Groundwater Transfer Review Summary Form

Transfer/PA # T- 13682 (RA)

Application: T-13682

Applicant Name: Stratford Landscape Supply

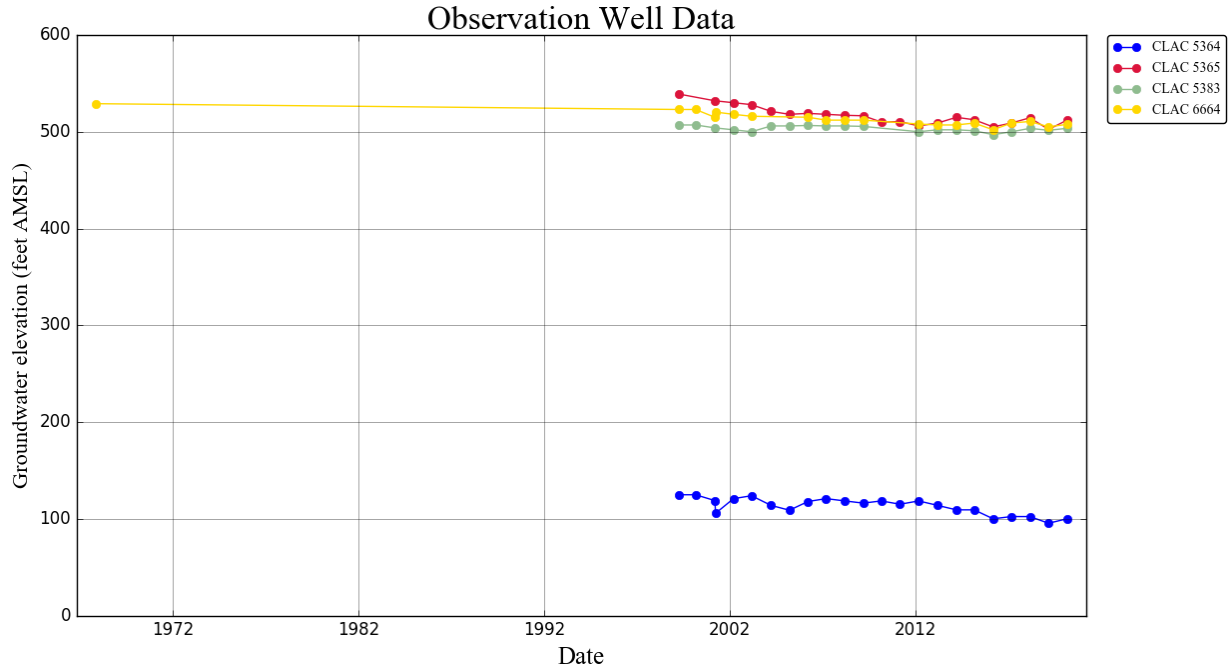
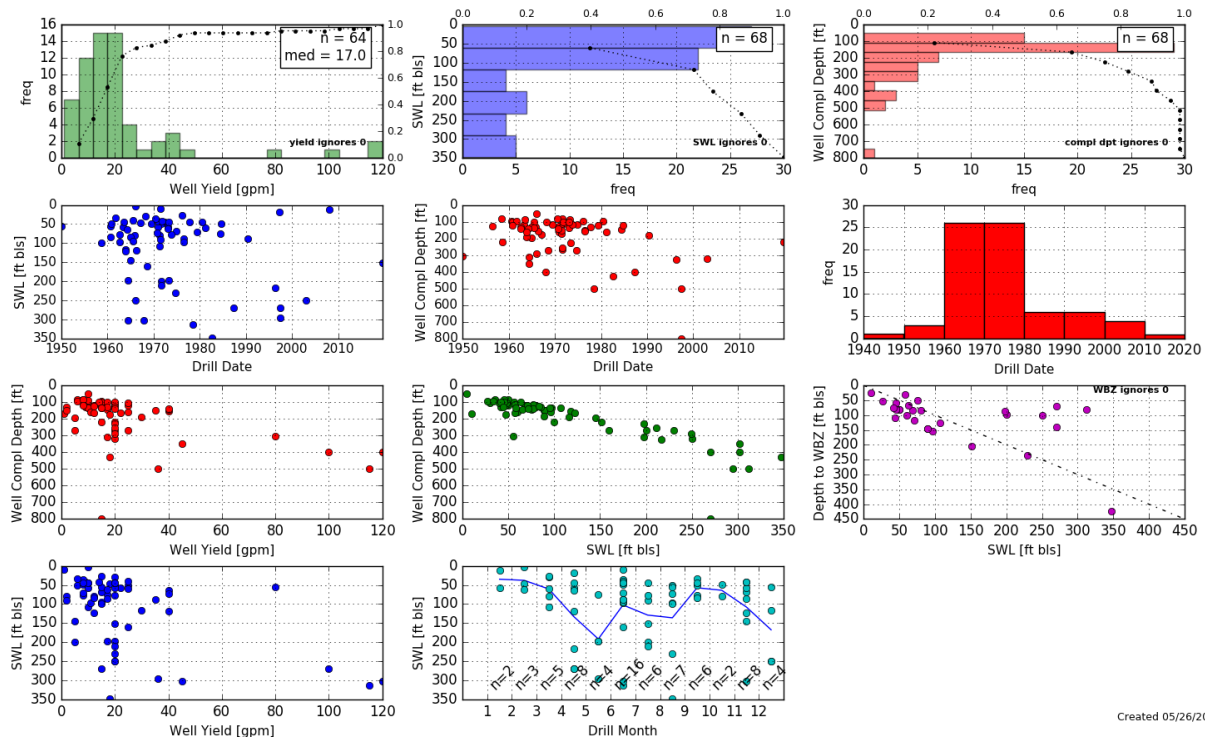
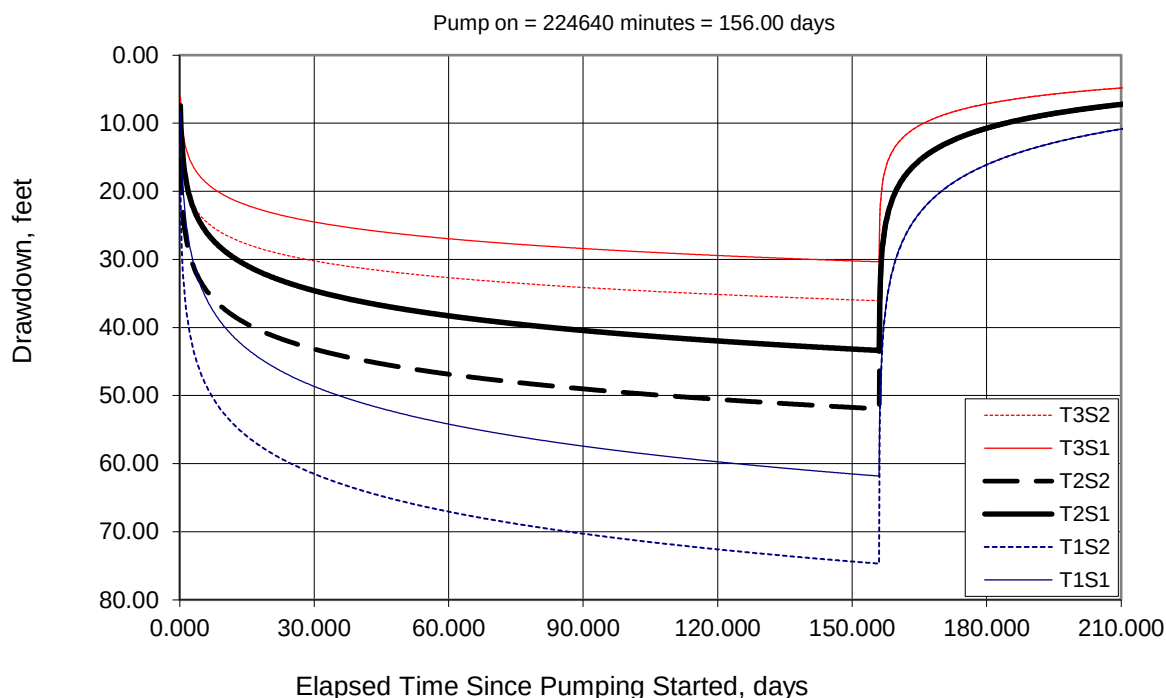
☒ Yes ☐ No If yes, explain: Specific well logs could not be correlated to tax lots 24E11AB00400 and 24E11AB00300, because of the presumed age of the exempt domestic wells and the incompleteness of well records from the 1960s and 1970s. Therefore, a Theis (1935) drawdown analysis was used to assess the likely radius around the proposed To-POA Well 5 and Well 6 within which a neighboring well would likely experience substantial or undue interference (SUI) as defined in OAR 690-008-0001(8)(c) (see Theis Drawdown Analysis, attached). Results of the analysis indicate that, at the maximum allowed rate of use (0.465 cfs), proposed To-POA Well 6 would likely result in SUI with a neighboring exempt domestic well on tax lot 24E11AB00400 (see attached Well Location Map for a depiction of the likely radius of SUI around proposed To-POA Well 5 and Well 6). The likelihood of SUI could be reduced by moving the location of proposed To-POA Well 6 to a point greater than ~350 ft from tax lot 24E11AB00400 or reducing the maximum rate from proposed To-POA Well 6 to less than 0.115 cfs (assuming that proposed To-POA Well 5 would pump the remaining 0.350 cfs of the total combined rate of 0.465 cfs which is the subject of this transfer).
